QTY REQD		ITEM NO	REF DES	CAGE NO	PART OR IDENTIFYING NO	NOMENCLATURE OR DESCRIPTION	SPECIFICATION	MATERIAL OR NOTE	ZONE
					20007921-1				
					PARTS LIST				
CONTRACT NO		UNLESS OTHERWISE SPECIFIED DIMENSIONS ARE IN INCHES TOLERANCES		RELEASED 2/17/2005		ALLIANCE SPACESYSTEMS, INC. 1250 Lincoln Ave., Suite 100 Pasadena, CA 91103		REV B	
		DECIMALS .XX ±.03 ANGLES XXX ±.010 ±12°		MACHINE FINISH 63		BRACKET, STAGE 1-2 HORZ COIL ADAPTOR LIGO D7921-B		CAGE CODE 1KNU9	
		DO NOT SCALE DRAWING INTERPRET DWG PER ASME Y14.5M-1994		MATERIAL 7075 T651 AL ALLY PER AMS-QQ-A-250/12		DWN R.D.BILLING 07/07/04		SCALE 2:1	
FILE ATTACHMENTS		20007968 1388		20007921_x_1		UNCLASSIFIED		SHEET 1 OF 1

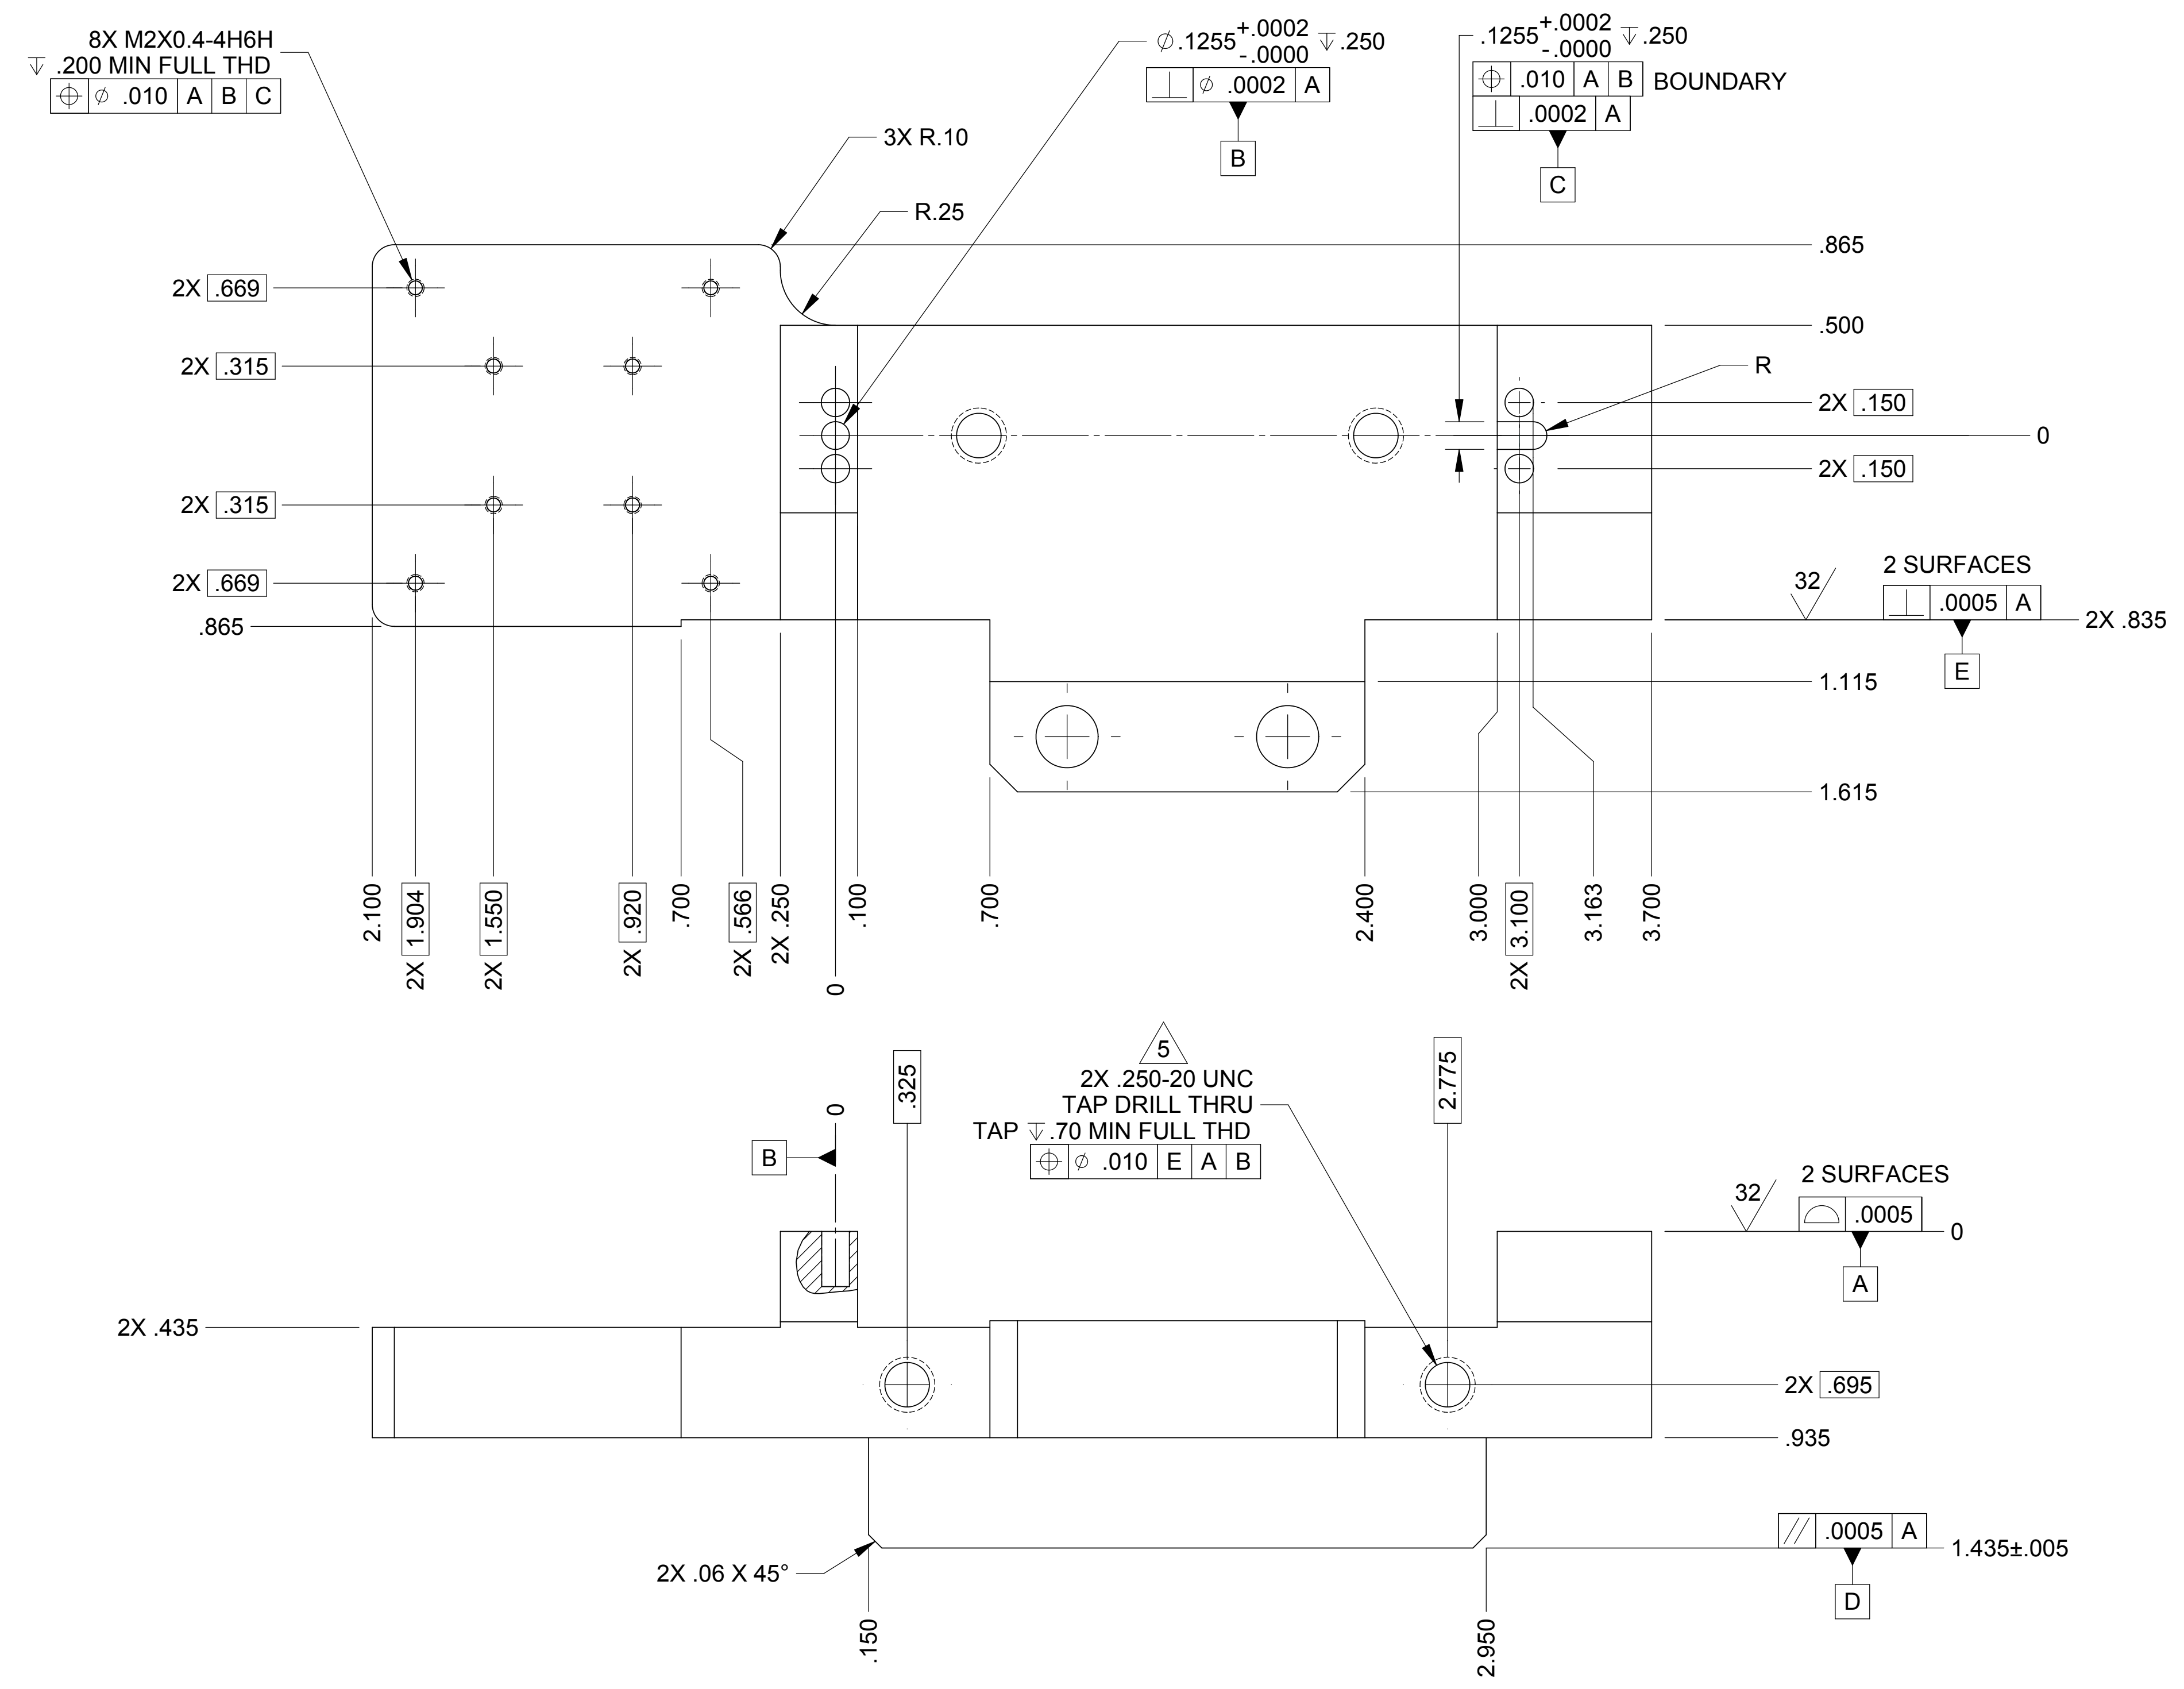
LTR		REVISIONS									
ZONE	DESCRIPTION	DWN	CHK	P-ENG	CONF	ME	STRS	MATL	PROJ	QA	RELEASE DATE
A	INITIAL RELEASE										1-24-05
B	250-20 UNC HOLE TAP CALLOUT WAS: ∇ 900 MIN. IS: THRU	RF		KS	RF		DK	DCW	DCW	SV	MK
